UNITED STATES  
NUCLEAR REGULATORY COMMISSION  
WASHINGTON, D. C. 20555

DEC 07 1976

FACILITIES: Shoreham Nuclear Power Station Unit No. 1, Limerick Generating Station Units No. 1 and No. 2, William H. Zimmer Nuclear Power Station, Unit 1, Bailly Generating Station Nuclear No. 1, LaSalle County Station Units No. 1 and No. 2, Susquehanna Steam Electric Station Units No. 1 and No. 2, WPPSS Nuclear Project No. 2, Nine Mile Point Nuclear Station Unit No. 2.

SUMMARY OF MEETING HELD ON OCTOBER 27-28, 1976 TO DISCUSS THE MARK II CONTAINMENT POOL DYNAMIC LOAD PROGRAM

FIG. 1

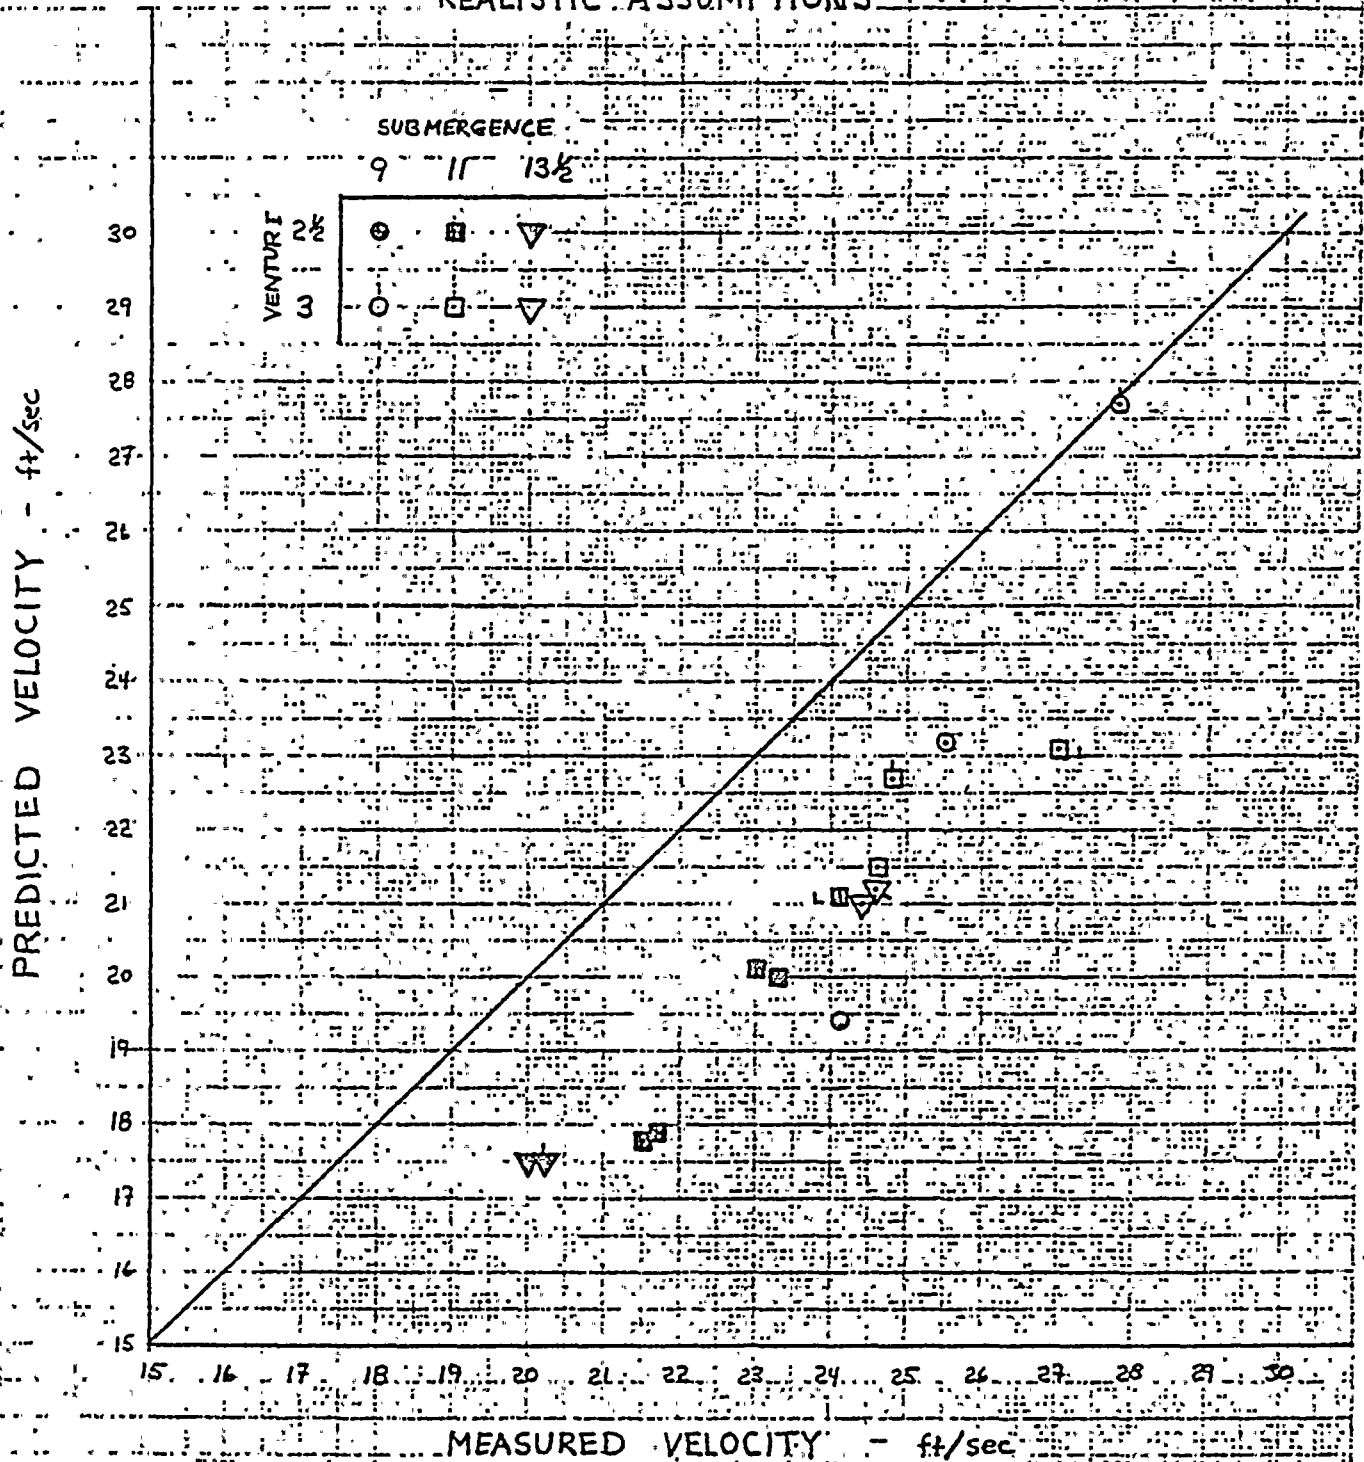
The staff identified a number of deficiencies in the pool swell model. GE provided a summary of the model assumptions (Table 1) along with a comparison of 4T test results with pool swell model predictions using both realistic and conservative DFFR assumptions (Fig. 1 & 2). The model predictions bracketed the test data. On this basis

General Electric concluded that the DFFR model using conservative assumptions is adequately conservative. The staff was unable to conclude on the adequacy of the DFFR model due to the limited nature of the model/test comparison. General Electric stated that the complete evaluation of the DFFR pool swell velocity/breakthrough model originally due in November will now be submitted in January 1977.
